# HISTORIC AND DESIGN REVIEW COMMISSION

**HDRC CASE NO:** 2022-135  
**ADDRESS:** 306 BELKNAP PLACE  
**LEGAL DESCRIPTION:** NCB 1887 BLK 7 LOT 12  
**ZONING:** R-4, H  
**CITY COUNCIL DIST.:** 1  
**DISTRICT:** Monte Vista Historic District  
**APPLICANT:** Robert Ziebell/WARD ROBERT S & ELIZABETH D  
**OWNER:** Robert Ziebell/WARD ROBERT S & ELIZABETH D  
**TYPE OF WORK:** Construction of a second story addition on an existing accessory structure  
**APPLICATION RECEIVED:** February 16, 2022  
**60-DAY REVIEW:** Not applicable due to City Council Emergency Orders  
**CASE MANAGER:** Edward Hall

The applicant is requesting a Certificate of Appropriateness for approval to construct a second story addition on top of an existing addition to the existing, historic structure on site. The lot addressed as 306 Belknap Place was part of the property addressed as 300 W French Place.

2nd Floor (Addition)

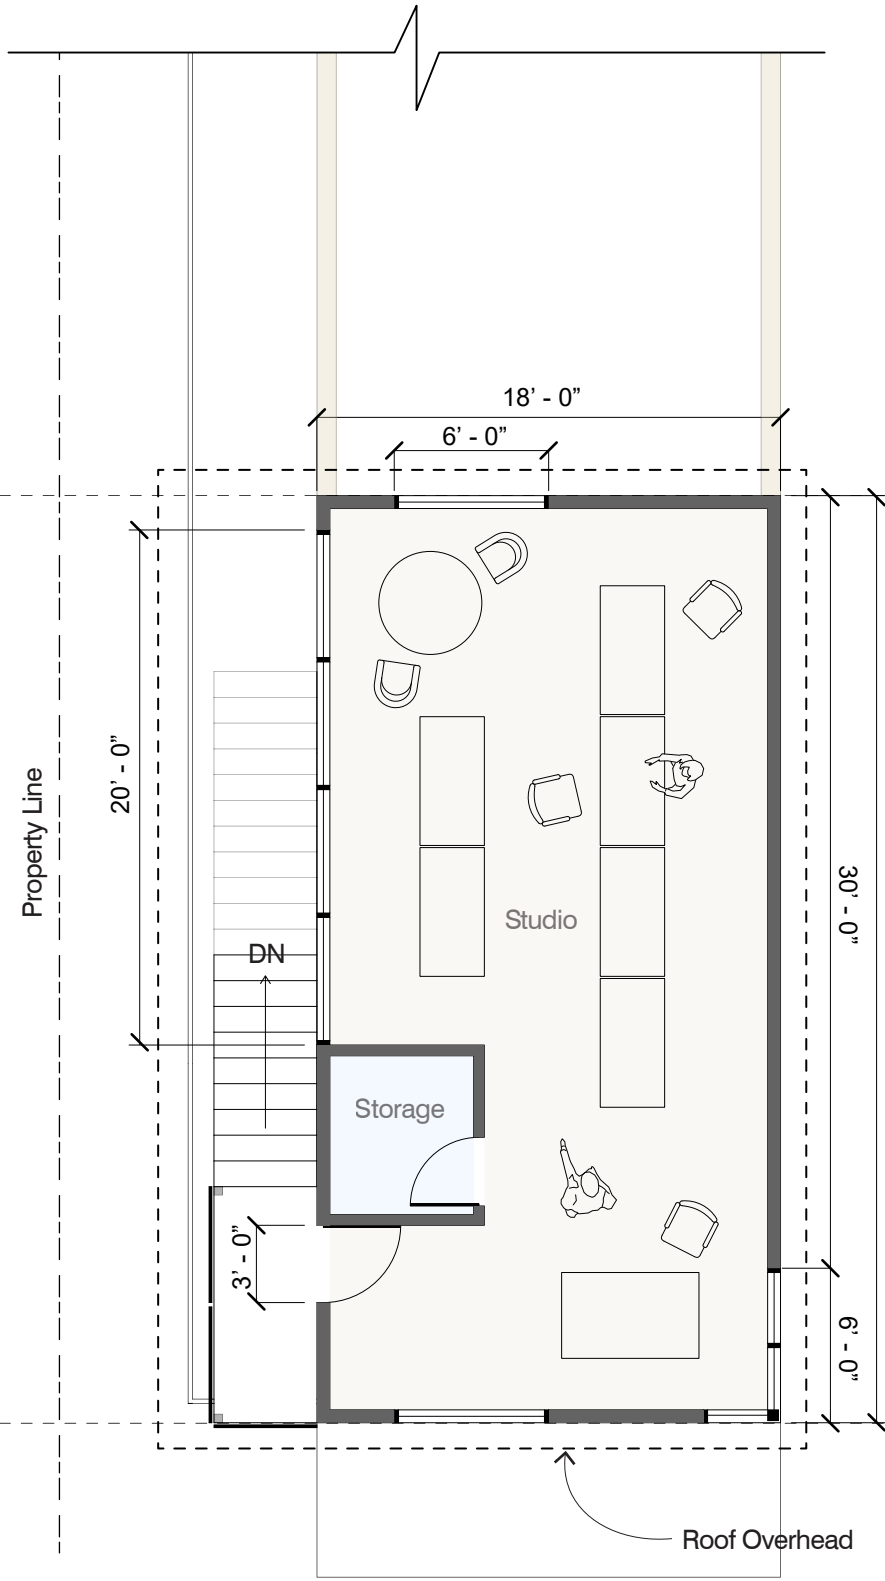
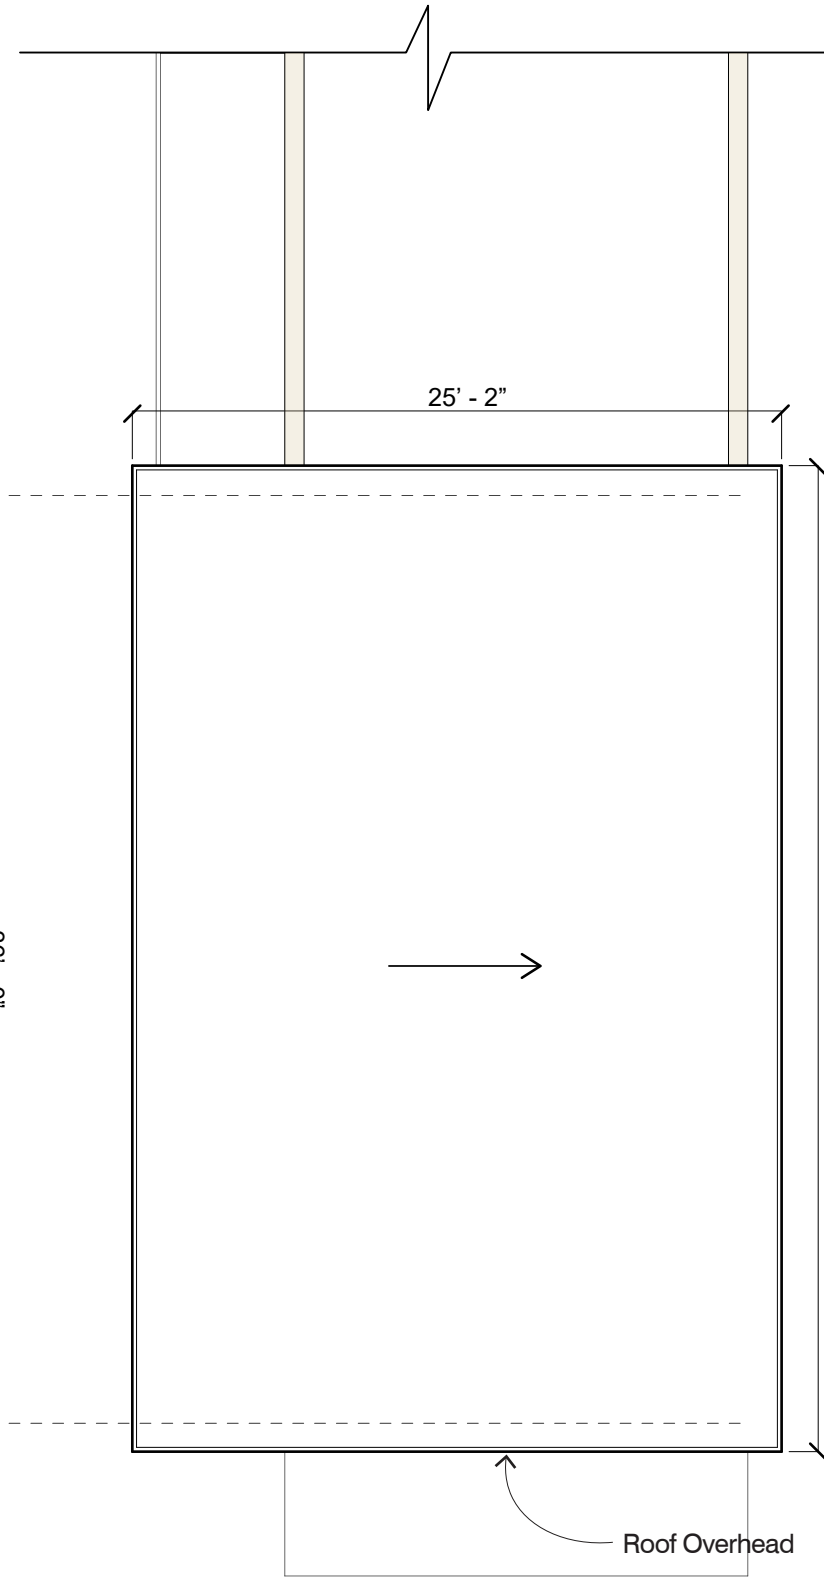
- c. ADDITION – The applicant has proposed to construct a second story addition on top of the existing, 1-story brick addition. The proposed addition is to feature 1-story in height, a footprint of approximately 648 square feet and a shed roof.

- d. ADDITION – The Guidelines for Additions 1.A. note that additions should be sited to minimize view from the public right of way, should be designed to be in keeping with the existing, historic context of the block, should feature a similar roof form and should feature a transition between the proposed addition and existing structure. The applicant has proposed for the rooftop addition to feature a shed roof. Roof forms found historically within the Monte Vista Historic District include gabled and hipped profiles as well as occasional flat roofs with decorative parapet walls. The proposed roof form is not consistent with the Guidelines.

- e. ADDITION – The Guidelines for Additions 2.B. note that rooftop additions should be limited to rear facades to preserve the historic scale and form of the building from the street level and minimize visibility from the public right of way. The Guidelines also note that full floor, second story additions that obscure the form of the original structure are not appropriate. Additionally, the Guidelines for Additions 2.B.v. note that the height of new additions should be consistent with the height of the existing structure. Generally, staff finds a second floor addition to be appropriate provided that it features a roof form, massing and architectural profile that are consistent with the Guidelines and complement the historic forms found within the district.

- f. ADDITION (Materials) – The applicant has proposed materials that include metal façade panels, brick, and a shingle or metal roof. The Guidelines for Additions 3.A. notes that materials that match in type, color, and texture should be used to be compatible with the architectural style of the original structure. Additionally, the Guidelines note that roofing materials for additions to structures with clay tile roofs should appear similar in color and dimension to the existing clay tile. Staff finds that brick to match the existing or stucco would be most appropriate for a primary material. Staff finds the use of metal to be inappropriate as a siding material. Staff finds that roofing materials that appear similar in color and dimension to the existing clay tile roof should be used and that the proposed roof form should be modified as noted in finding d.

- g. ADDITION (Windows) – The applicant has noted the installation of metal windows to be consistent with the aluminum windows of the existing addition. Staff finds that all windows should feature profiles that are consistent with those found historically within the district. Large expanses of glass that are not found historically within the district should not be incorporated into the design. Additionally, contemporarily sized windows should be modified to feature traditional sized and profiles. An aluminum window may be appropriate; however, it should be consistent with staff's standards for windows in new construction and additions.

- j. STAIRS – The applicant has noted the installation of stairs on the north side of the proposed addition. Staff finds the installation of stairs to be appropriate; however, a railing detail should be submitted for review and approval. Railing profiles should be consistent with those found historically within the district.

- i. That the applicant modify the proposed shed roof to feature a hipped roof, consistent with those found historically on site and the Guidelines as noted in findings d and h.

- ii. That the applicant install materials that consist of brick or stucco and clay tile or a visually similar material to result in an addition that is consistent with the Guidelines. Plastic roof tiles should not be used.
- iii. That the applicant modify the proposed fenestration profile to feature window locations, sizes and profiles that are consistent with those found historically within the district, as noted in finding g.
- iv. That window products be consistent with staff's standards for windows in new construction and additions, as noted in finding g and in the applicable citations.
- v. That a detail of the proposed railing be submitted for review and approval as noted in finding j.
